LEARNING RESOURCES CENTER
BUILDING 'D' AND 'CR' REMODEL

VENTURA COLLEGE

September 24, 2001
KBZ Job No. 93-18

INSPECTOR COPY

1 Topographic Mapping of Bldg. 'D'
SCALE: 1" = 10'-0"

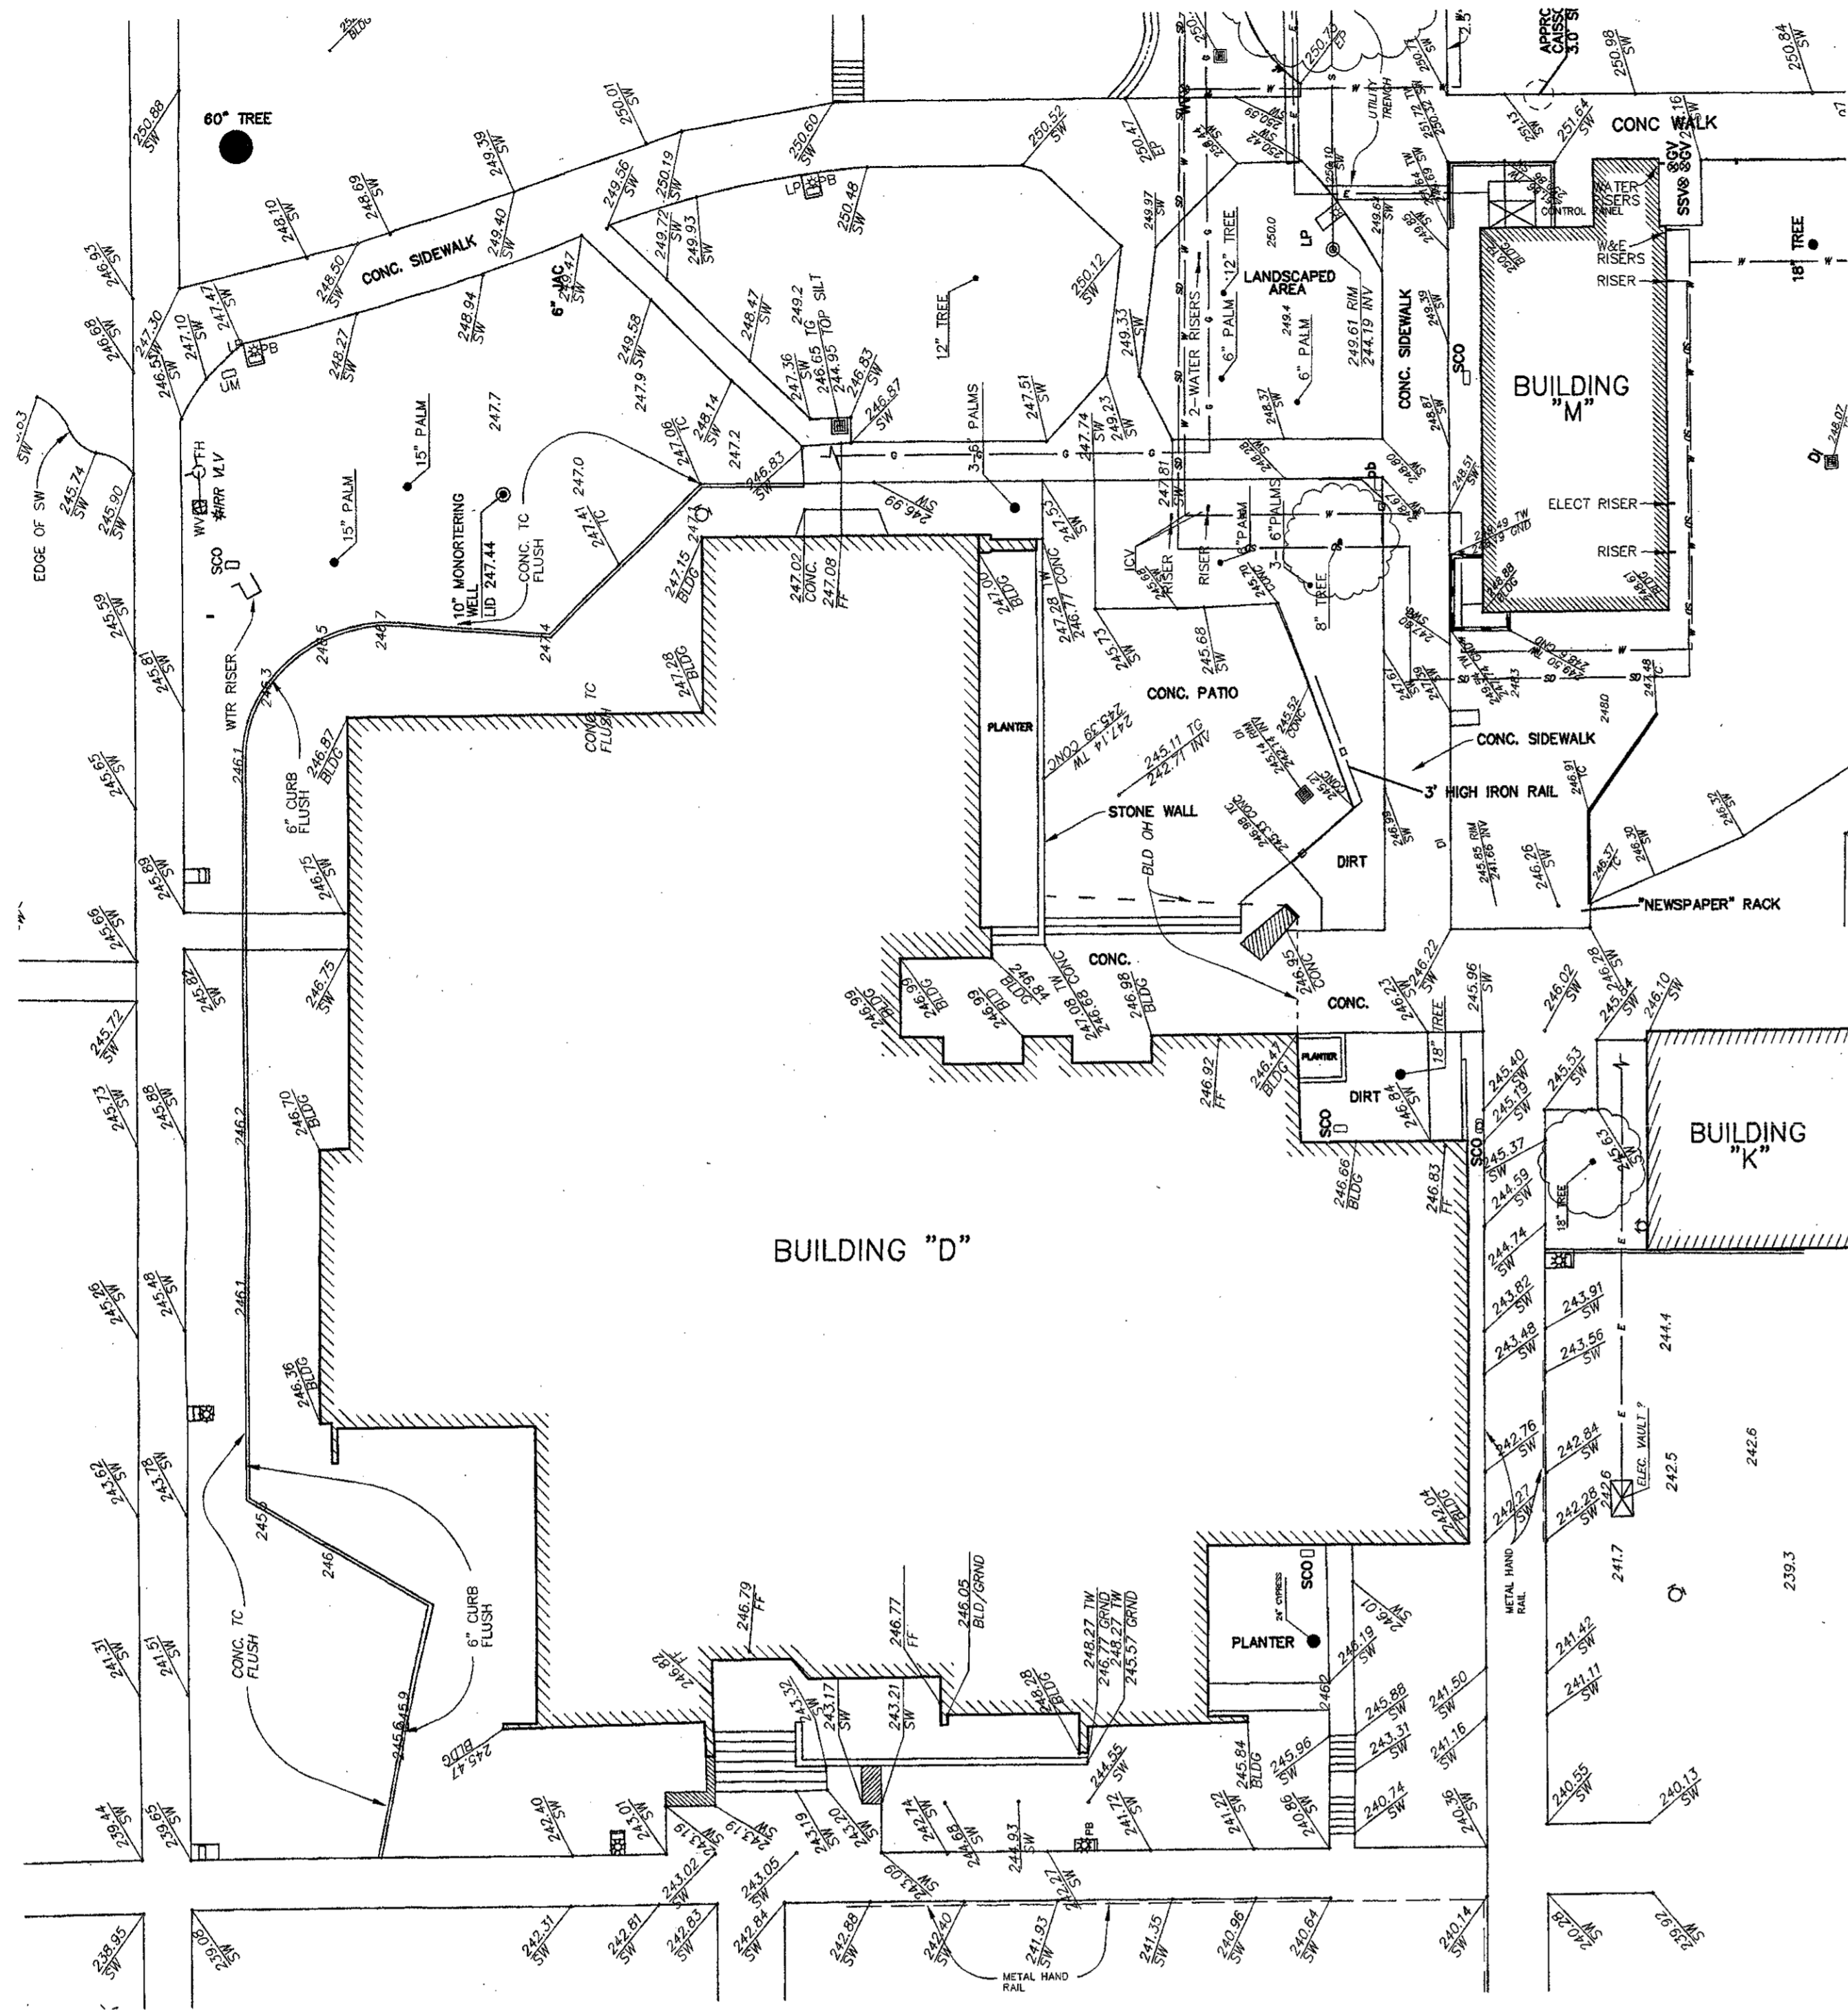
ITEM 16. Drawing Sheet C-101.
The scale of "1 Topographic mapping of Building 'D'" is changed from 1" = 10'-0" to 1" = 20'-0".

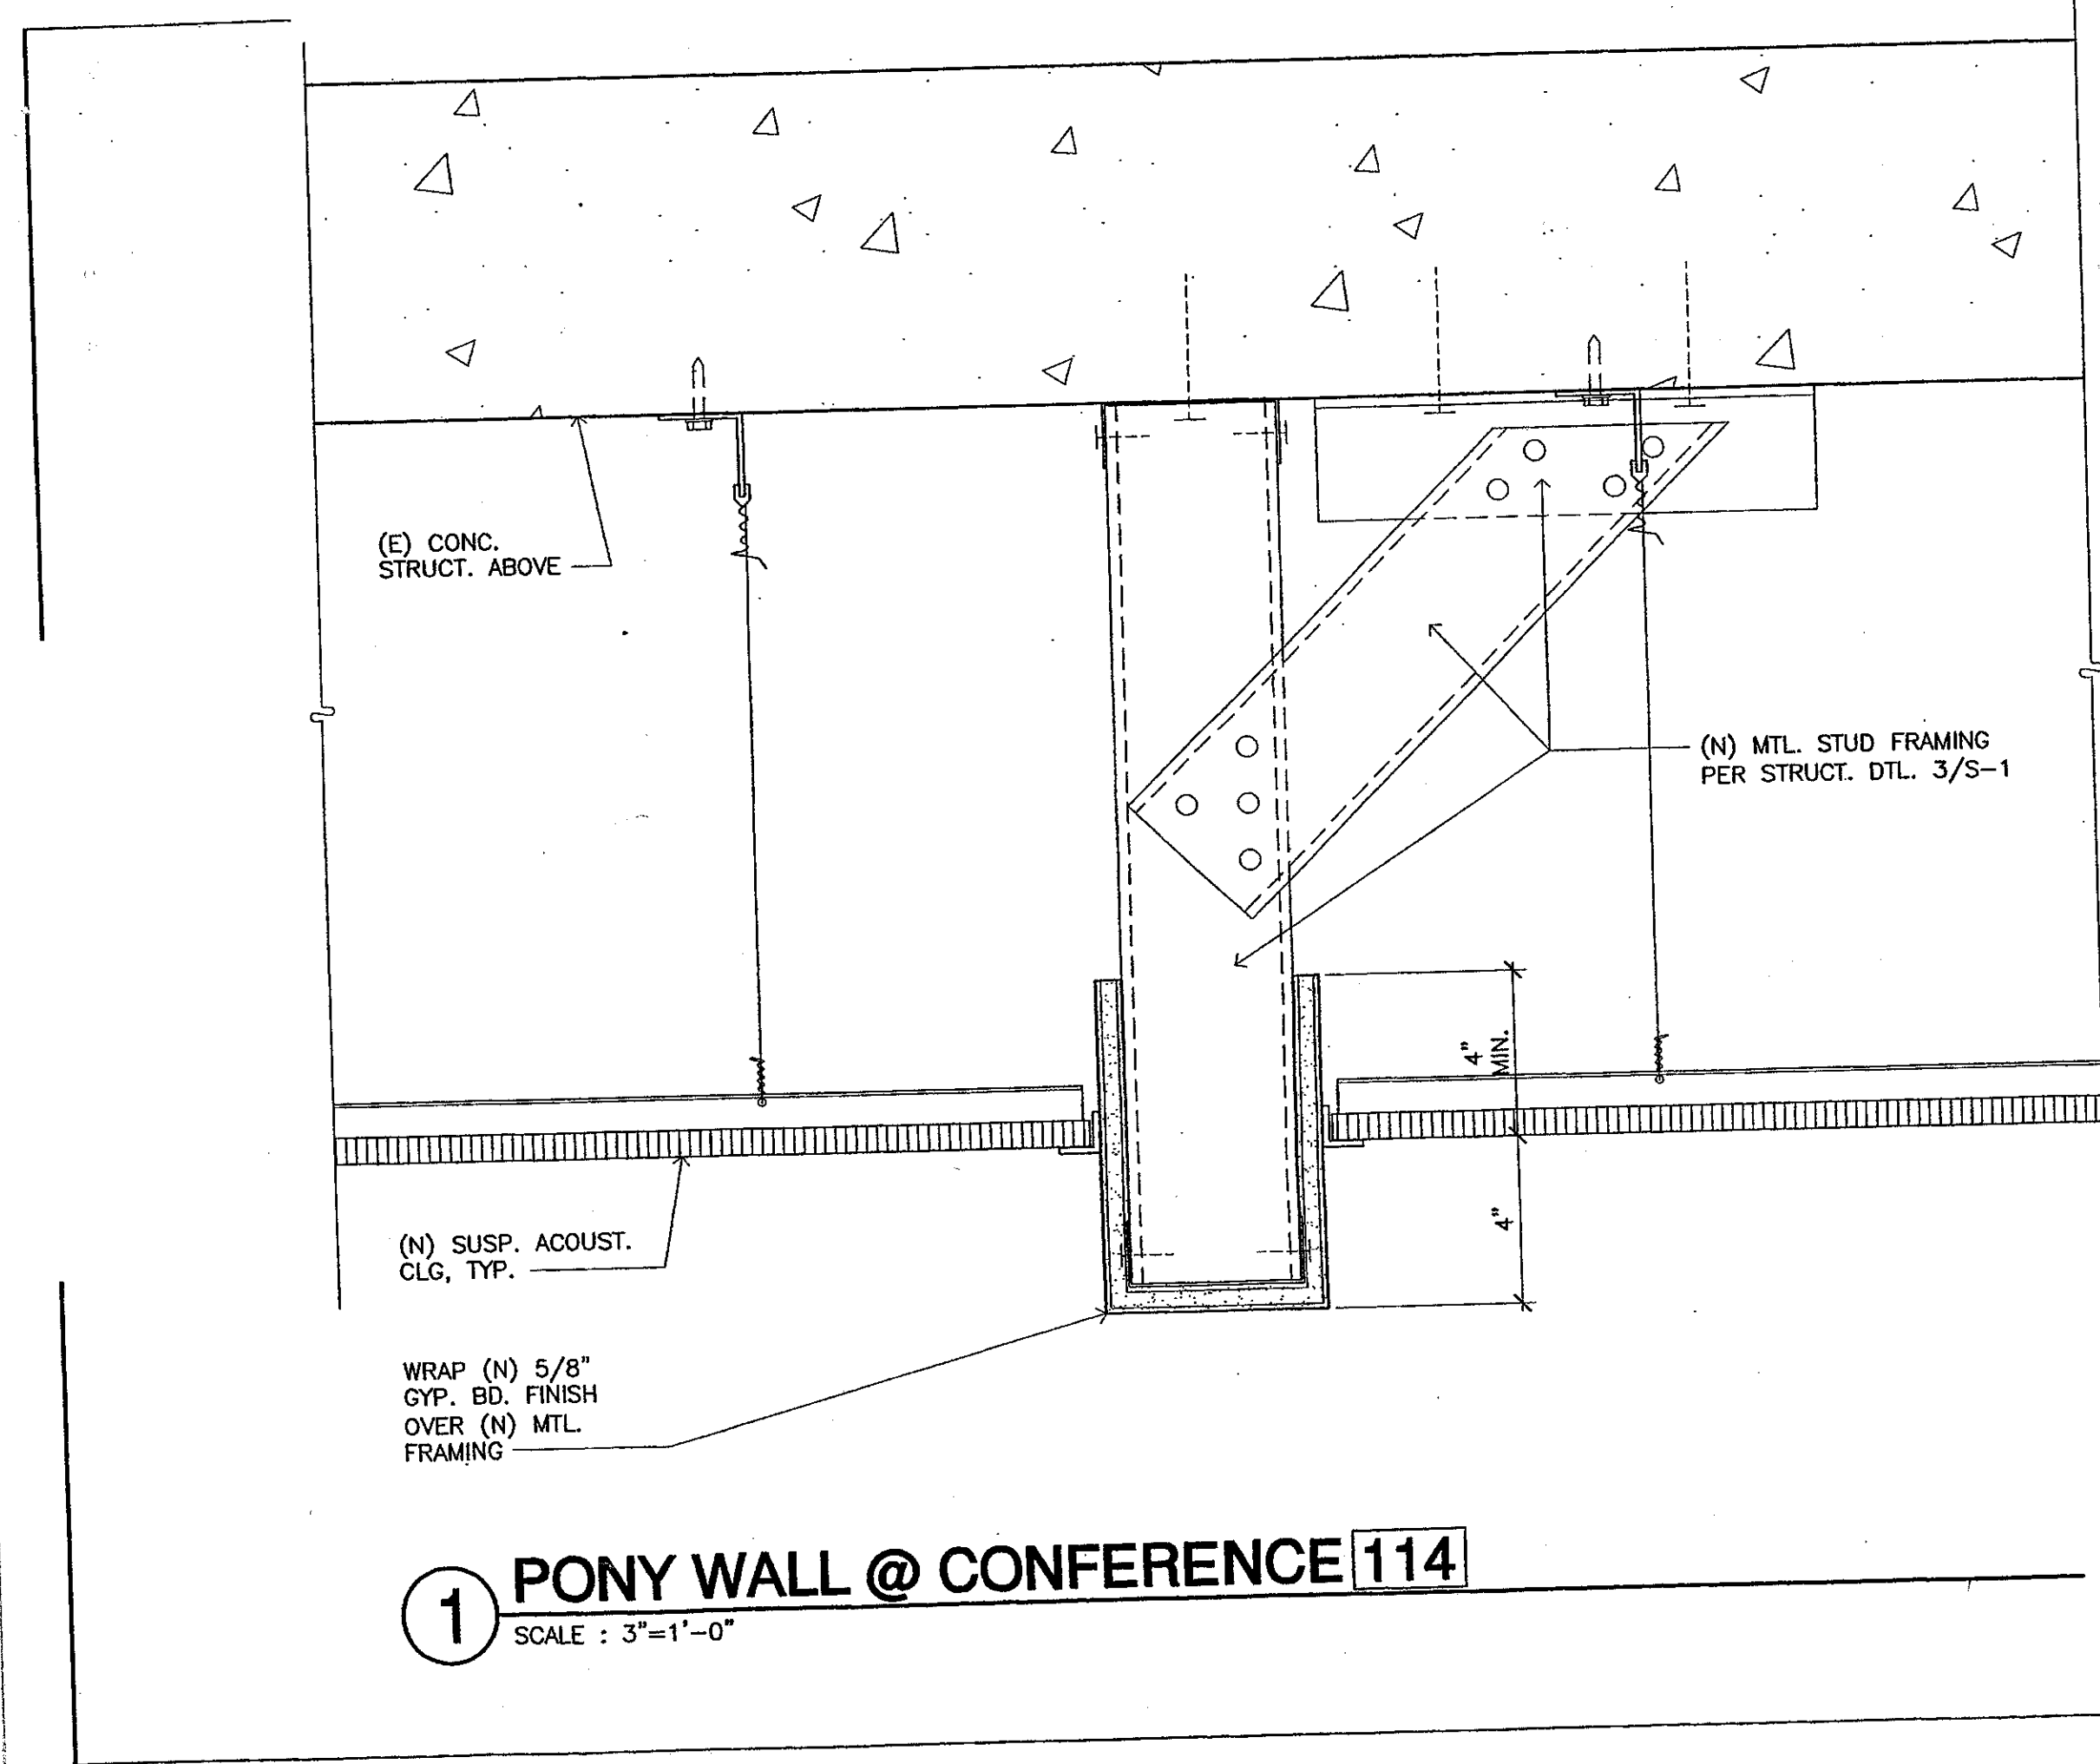
Item No. 6: Drawing Sheet A-111
Omit rooms 111, 112, 113, 115, 116 and all references as modified by architectural revision drawing series AR1, Addendum Number 6. Change VISITING REP. 110 to CONFERENCE ROOM 110 and OFFICE 114 to CONFERENCE 114 and all references as modified by architectural revision drawing series AR1, Addendum Number 6. Add OFFICE 111 as modified by architectural revision drawing series AR1, Addendum Number 6.

ITEM 19. Drawing Sheet A-111.
Keynote 20 is revised to read: "(N) Tall cabinet- additive bid alternate C." This tall cabinet shall be W.I.C. design no. 412 36" long, 30" deep and 84" high. Provide a drop down gypsum board/steel stud framed soffit to the top of the cabinet.
The (N) work table/cabinet in Student Business Office 139 identified in keynote 40 as Additive Bid Alternate C is further described below:
10'-0" total length x 36" deep x 34" high to top of laminated plastic counter top. Base cabinets to consist of three equal length units- W.I.C. Design no. 212, with a 6" wide utility chase between the center unit and northerly most unit.
Provide an access door at the front of the utility chase full height of cabinet.
Electric power and data outlets shall be installed on side wall inside chase access hole through the counter top above for power cords Cabinet doors and drawers to face east. Provide finished ends and back with toe recess all around.

ITEM 20. Drawing Sheet A-111.
a. Two W.I.C. type cabinet units are shown in the northeast area of Student Business Office 139 on the south side of dashed (E) furniture by Owner (WIC) (Keynote 17). These are 42" high freestanding units with laminated plastic countertop similar to W.I.C. Design No. 160 (without side guides) - length to accommodate Owners furniture (coordinate with Owner) x 15" deep x 42" high. Finished laminated plastic all surfaces, inside and outside- ends, backs, and edges.
b. At Men's Restroom 146 add a solid plastic urinal screen between the urinals per Specification Section 10155.
c. The opening in the existing concrete wall (East wall of Secretary 118) immediately south of Door 109 is to receive a new "J" type aluminum window.
d. The window type called out above doors 135 through 141 at offices 130 through 136 is changed from "K" to "L".

Item No. 1: Drawing Sheet A-111 First Floor Plan- Building 'D' ADDENDUM 4
and Keynote 21 Systems Furniture Layouts F, G, and H at Rooms 102, 106, and 128 are deleted. Layout A, B, C, D, and E remain as additive alternate A.

Item No. 2: Drawing Sheet A-111
Keynote 20 is changed to read: "(N) tall cabinet- bid alternate C."

Item No. 3: Drawing Sheet A-111 First Floor Plan- Building 'D'
At Career Center 106B, delete the tall cabinet identified by Keynote 20 located at the West Wall between Office 112 and Career Specialist 111.

Item No. 4: Drawing Sheet A-111 First Floor Plan- Building 'D'
At Student Business Office 139 the tall cabinet in the South East Corner identified by Keynote 20 is not shown on interior elevations and is clarified to be W (Woodwork Institute) Design No. 412, 36" long, 30" deep, and 74" high.

Item No. 5: Drawing Sheet A-111 First Floor Plan- Building 'D'
Keynote 37 and Drawing Sheet A-409, Interior Elevation 4, At On-Line Registration 156 the printer table/cabinet identified by Keynote 37 is revised in design as described on attached revision Drawing AR 9.0.

Item No. 6: Drawing Sheet A-111 First Floor Plan- Building 'D'
The design of work table/cabinet identified by Keynote 40 is described on attached revision Drawing AR 8.0.

Item No. 7: Drawing Sheet A-111 First Floor Plan- Building 'D'
And all referenced Drawing Sheets describing cabinet work and low partitions listed below as deductive alternates. The following cabinet work and low partitions are omitted from the contract work under deductive alternate F as described on attached revision Drawings AR 3.0, AR 4.0, AR 5.0, and AR 6.0: Reception Counter at Information 107; Transfer Center 106A; Work Stations at Computer On-line Registration 156; low partitions at Waiting 125; Reception Counter at Counseling Reception 126; Low Partitions at Counseling Waiting 128.
